**Application Number: F/YR12/0837/F**  
**Minor**  
**Parish/Ward: Leverington Parish Council**  
**Date Received: 26 October 2012**  
**Expiry Date: 21 December 2012**  
**Applicant: Mr I Esgate**  
**Agent: Peter Humphrey Associates Ltd**

**Proposal: Erection of a 2-storey 3-bed dwelling**  
**Location: Land north of Salud, Church End, Leverington, Cambridgeshire**

**1. EXECUTIVE SUMMARY/RECOMMENDATION**

Proposed Site Plan 1:250

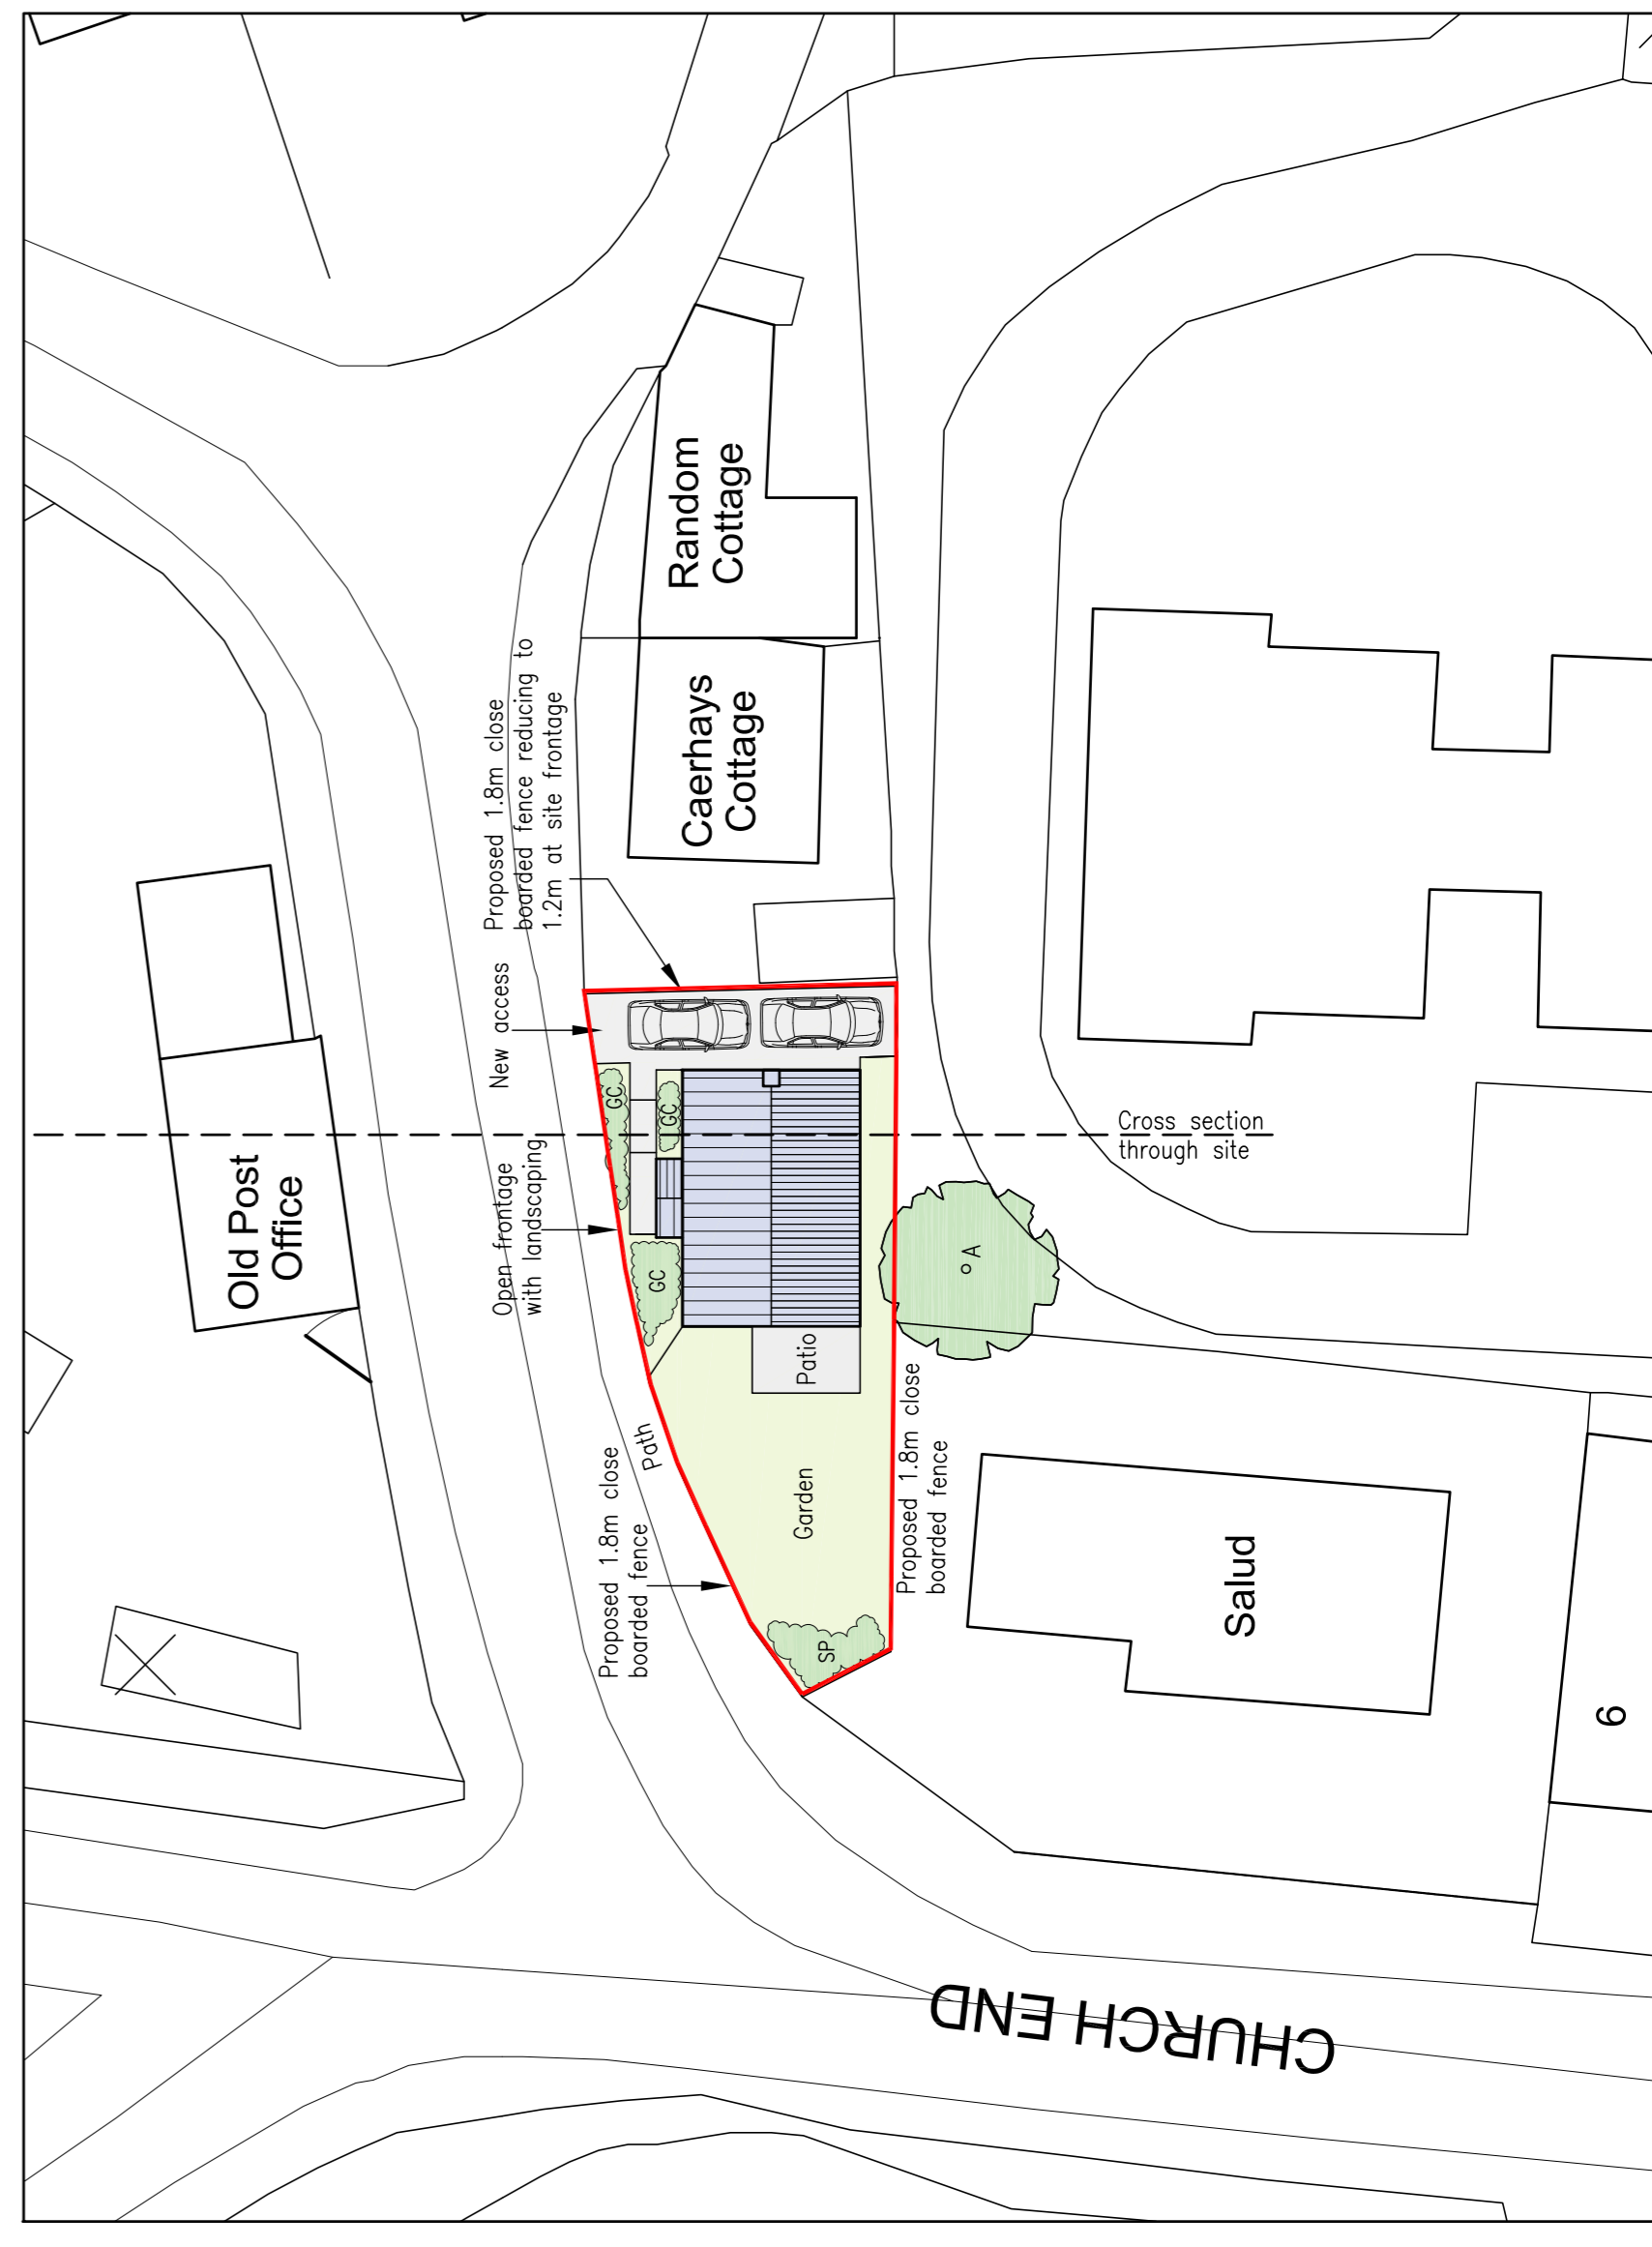
Proposed layout currently does not meet the requirements; the required visibility splay to the east crosses adjacent third party land. Request an amended layout plan.

CCC Highways have commented that the proposed layout does not meet its requirements and the required visibility splay to the east crosses adjacent third party land. CCC have requested an amended layout plan, this request has been forwarded to the applicants agent to address. CCC Highways have outlined that if the applicant is unable/unwilling to provide the splays a recommendation of refusal is likely.
